# EAGLE SERVICE INSTRUCTION

TO AMEND INSTALLATION INSTRUCTIONS IIN-E205-828 REV. B OR LATER APPROVED REVISIONS  
REF. TCCA STC: SH13-46  
REF. FAA STC: SR03461NY

Eagle Service Instruction Number: **ESI 9739**

Description: **E4702-041 Ladder Modification**

**FIGURE 1 - D4702-041 LADDER MODIFICATION**  
(SERVO ATTACHMENT BOLTS REMOVED FOR CLARITY)

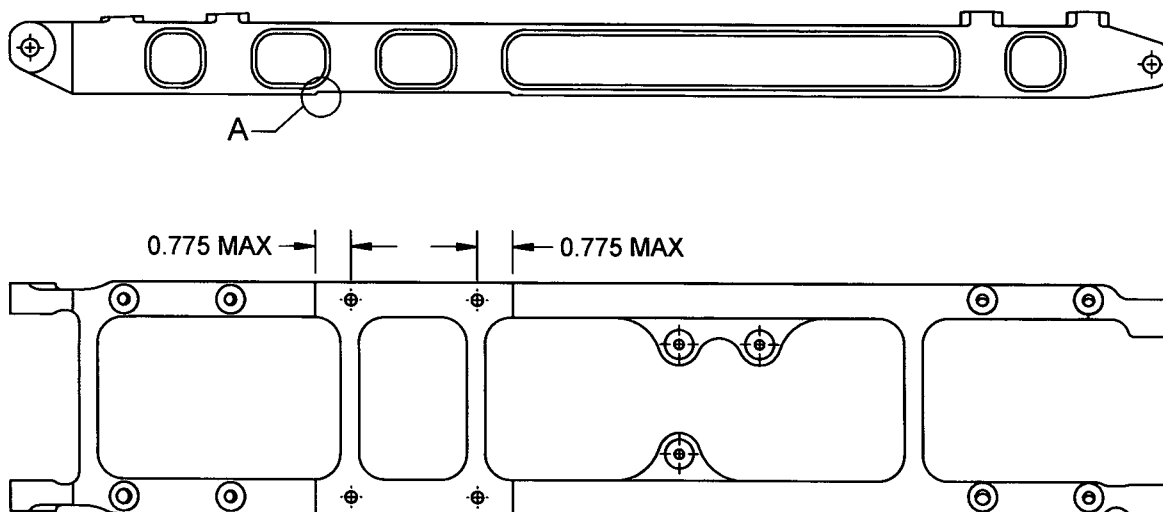
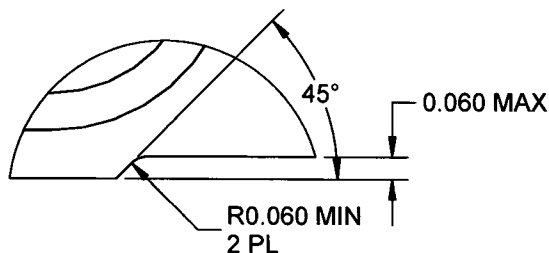
During the installation of the E205-828-011 Dual Hydraulic Collective Control System, it has been discovered that some aircraft may vary with respect to the location (height) of the lift beam. This variation may cause the holes at either end of the E4702-041 Ladder Assembly to be mis-aligned with their attachment holes. This ESI give instructions for the removal of material in order to achieve alignment of the attachment holes.

1. Remove material from the bottom of the E4702-041 Ladder Assembly in the area of the lift beam attachment for the purposes of achieving alignment of the Ladder Assembly attachment holes to a maximum of 0.060". See Figure 1 for details.

Note: Surface finish after machining must be no greater than 80 microinch

2. Liquid Penetrant Inspect part after machining per ASTM 1417 Level 2
3. Touch up machined surface with Alodine 1200/1201 per MIL-C-5541 and prime per aircraft Maintenance Manual
